Amendments to the Drawings:

“Annotated Sheets Showing Changes” and “Replacement Sheets” for Figs. 4, 7, 10, and 12 are enclosed herewith.

FIG. 10

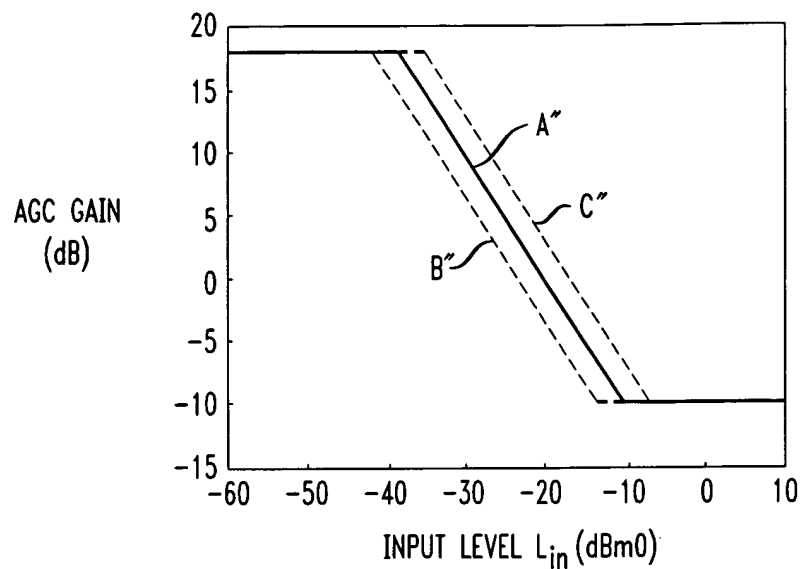
In Fig. 10, the lines labeled A, B, and C have been relabeled A", B", and C" to differentiate them from the lines labeled A, B, and C in Fig. 4. The dashed line A" has been redrawn as a solid line for consistency.

FIG. 7

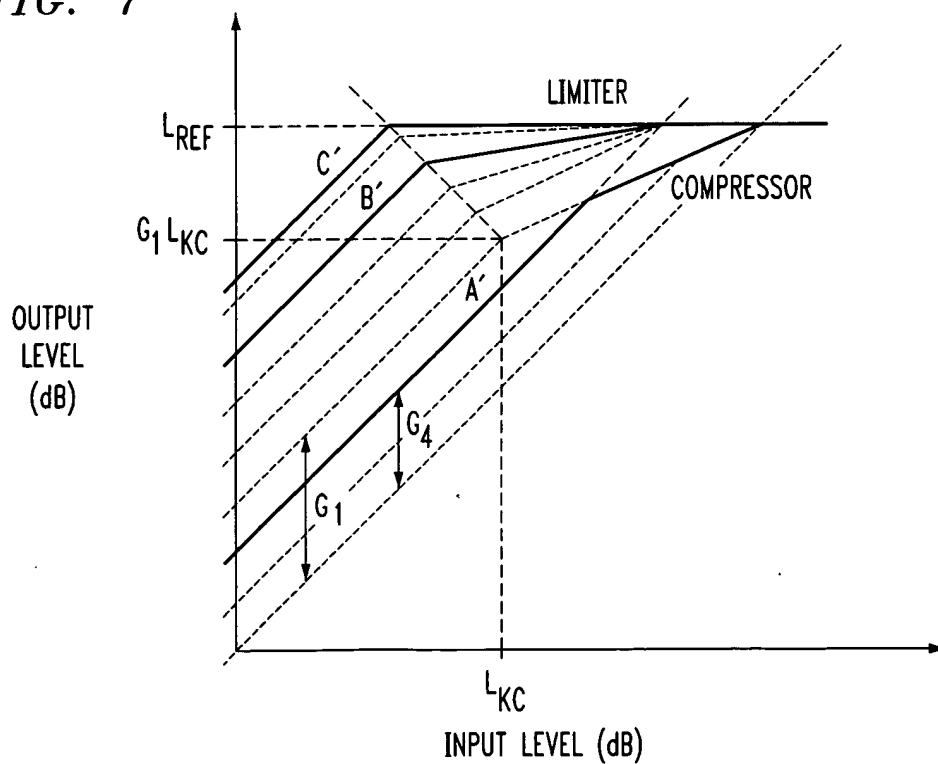
In Fig. 7, the lines labeled A, B, and C have been relabeled A', B', and C' to differentiate them from the lines labeled A, B, and C in Fig. 4.

FIG. 4

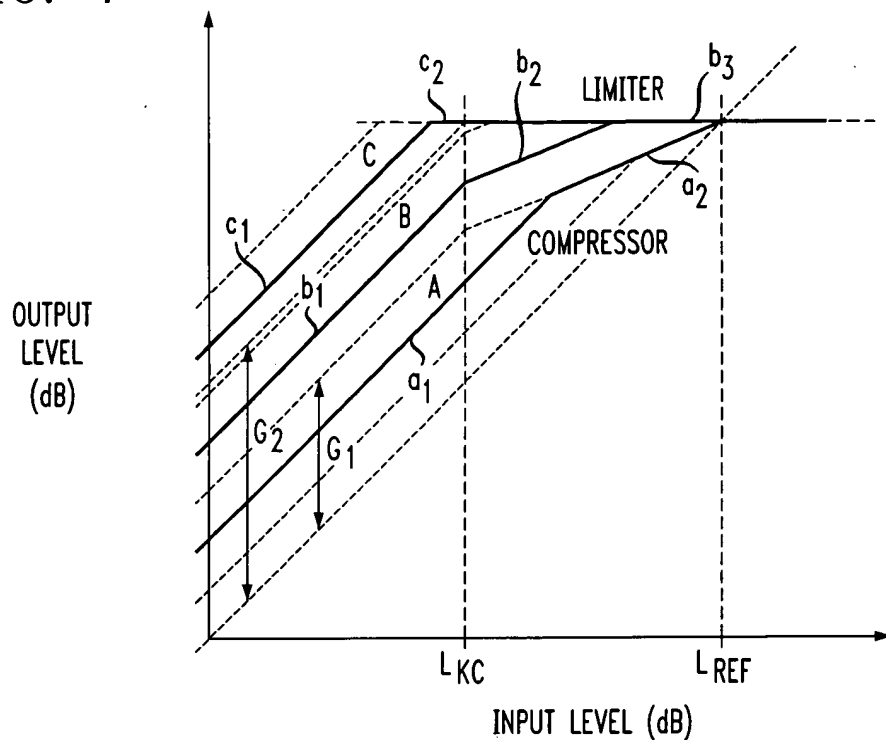
In Fig. 4, the composite line comprising sections a_1 and a_2 has been labeled by adding the letter A. The composite line comprising sections b_1 , b_2 , and b_3 has been labeled by adding the letter B. The composite line comprising sections c_1 and c_2 has been labeled by adding the letter C. These changes have been made consistent with the specification's references to lines A, B, and C in paragraph [0043].
